Access Compliance Report

Public Rights-of-Way

(Curb Ramps)

Intersection ID: 29797	Main Street: CHELTON RIDGE LN	Cross Street: DESTIN LN	Location: NE
ADA ID: 966B7EE7177D	Ramp Type: PerpDiag	Initial Pass/Fail: Fail	Overall Compliance: No
Severity Score: 13.75			
Codes/Mitigation Info/Possible Solution		Field Measurements/Component Compliance

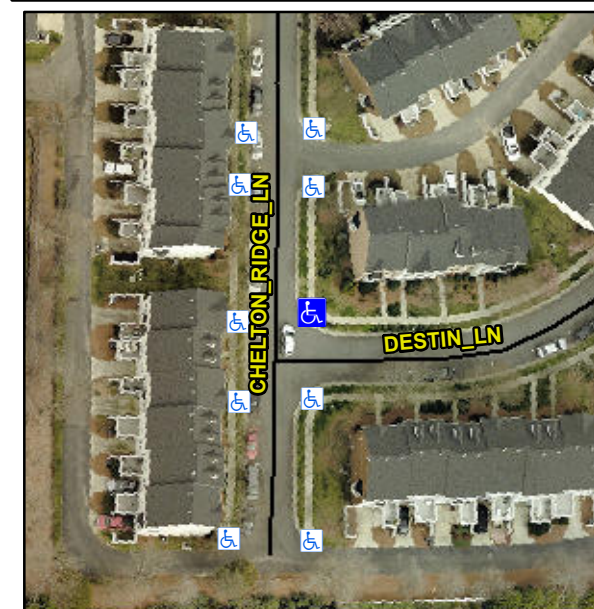
R304.2.2, R304.5.3

Compliance	Description	Data	Compliance	Description	Data
N/A	Ramp Length (in)	47.0	No	Ramp Slope (%)	11.9
Yes	Ramp Width (in)	57.0	No	Ramp XSlope (%)	3.5
N/A	Flare Type LT	N/A	N/A	Flare Type RT	N/A
N/A	Flare Slope LT (%)	N/A	N/A	Flare Slope RT (%)	N/A
N/A	Flare Traversable LT?	N/A	N/A	Flare Traversable RT?	N/A
N/A	Landing Length (in)	N/A	N/A	DWS Provided?	N/A
N/A	Landing Width (in)	N/A	N/A	DWS Contrast?	N/A
N/A	Landing Slope (%)	N/A	N/A	DWS Length (in)	N/A
N/A	Landing X Slope (%)	N/A	N/A	DWS Full Width?	N/A
N/A	Landing Curb? (Y/N)	N/A	N/A	DWS Offset (in)	N/A
N/A	Shared Landing?	N/A			
N/A	Gutter Ponding?	N/A	N/A	Gutter Slope (%)	N/A
N/A	Gutter Lip Ht (in)	N/A	N/A	Gutter X Slope (%)	N/A
N/A	Painted X Walk1?	No	N/A	Painted X Walk2?	No
	X Walk 1 Direction	To W		X Walk 2 Direction	To S
N/A	X Walk 1 Width (in)	N/A	N/A	X Walk 2 Width (in)	N/A
	X Walk 1 Slope (%)	1.0		X Walk 2 Slope (%)	4.8
	X Walk 1 X Slope (%)	3.7		X Walk 2 X Slope (%)	0.8

N/A	Ramp inside XWalk1?	N/A	N/A	Ramp inside XWalk2?	N/A
	Road Slope (%)	2.0	N/A	Clear Space?	N/A
	Road X Slope (%)	2.1	N/A	Clear Space to XWalk (in)	N/A
N/A	Any Obstructions?	N/A	N/A	Storm Grate/Utility Hazard?	N/A
	Obstruction Type			Storm Grate/Utility Type	
		N/A			N/A
		Yes		Surface Condition? (G/P)	Good

Remove & Replace Curb Ramp With Two New Directional Ramps or Equivalent.
